Technical Service Bulletin: TSB110084

Water Pump Improvements

This document introduces product improvements to the coolant and oil seal of the water pump used on K38, K50, QSK45, and QSK60 engines. Recently, concerns have been raised about water pump seals leaking oil and water on these engines. Water seal leakage is generally due to filming deposits on the seal faces. This can be attributed to inadequate antifreeze concentration, poor coolant condition, poor water condition, increased levels of supplemental coolant additives (SCA), or the inability of the seal to disperse heat. Oil seal leakage is due to an excess of hot engine oil building up in the water pump drive and oil seal durability.

Figure 2, Existing Water Seal, Part Number 3089056

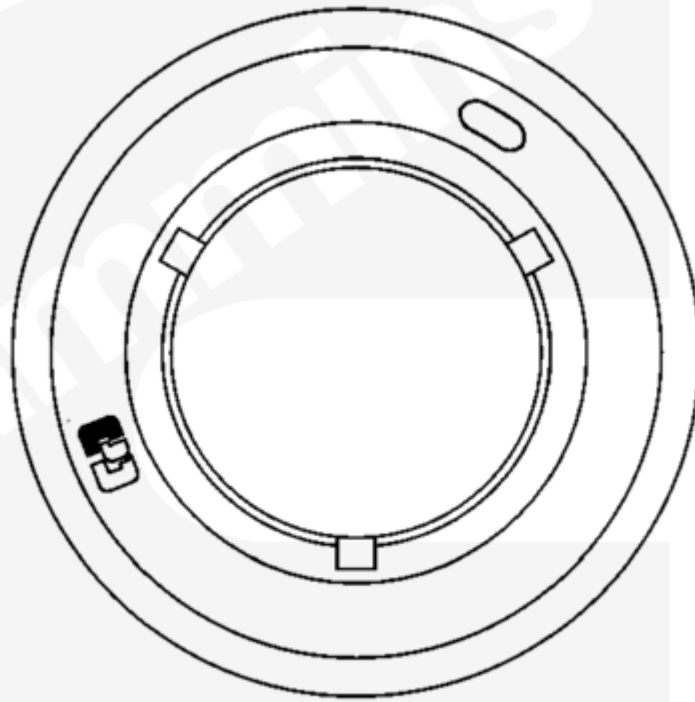
- A new shaft, Part Number 3643961, has been released for water pumps on K38, K50, QSK45, and QSK60 engines. The new shaft is backward/forward compatible. The old shaft, Part Number 3626952 and Part Number 3634049, can continue to be used in new and existing pump bodies.
- The new water seal is similar in appearance to the old water seal. Reference Figures 2 and 3 below for a comparison view of the old and new water seal. Figure 2 shows the old water seal, Part Number 3089056, with the retaining ring having three notches holding the seal halves together. Figure 3 shows the new water seal, Part Number 3634007, with a one-piece retaining ring design.

Do not fit the new seal in an existing pump body. Doing so can cause rapid seal failure.
